UNITED STATES PATENT AND TRADEMARK OFFICE

10/663,051

DETAILED ACTION***Drawings***

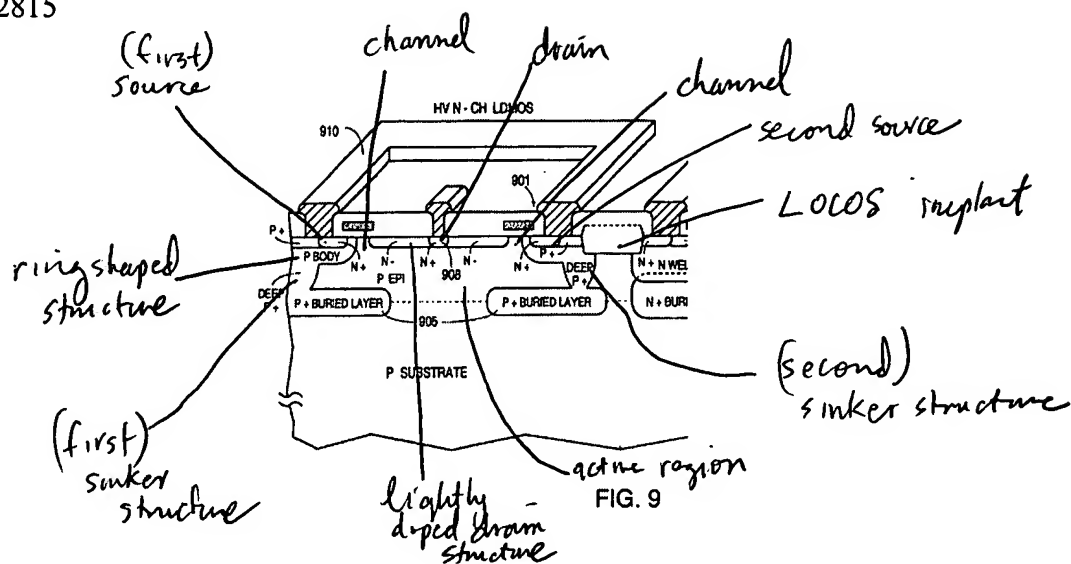
4. Claims 1 thru 4, 6, 11 thru 13, 16, 18 thru 21, 23, 25 thru 27, 30, 32 thru 35, 37, 39, 41, and 42 are rejected under 35 U.S.C. 102(b) as being anticipated by Williams et al. 5,386,136. Williams discloses (see, for example, FIG. 9) a semiconductor device comprising a p epitaxial region (active region of a first conducting type), transistor, and P-body (ring shaped region of the first conductive type). In column 8, lines 29-32, Williams discloses the P-body as being an annular structure (ring shaped).

Regarding claims 2, 19, and 33, see N+ region (drain) 908, N+ region (source), channel, gate, and deep P+ region (sinker structure).

Regarding claims 4, 21, and 35, see N- region (lightly doped drain region) next to the N+ region 908.

Regarding claims 6, 20, and 34, see FIG. 9 above wherein two transistors share a N+ region (common drain) 908, have a first source region and a second source region each defining a channel and first and second deep P+ regions (first and second sinker structure).

Regarding claims 11, 25, and 39, see FIG. 9 above wherein a LOCOS implant encloses semiconductor device.

Regarding claims 12 and 26, see FIG. 9 above wherein a P substrate and P epitaxial layer.
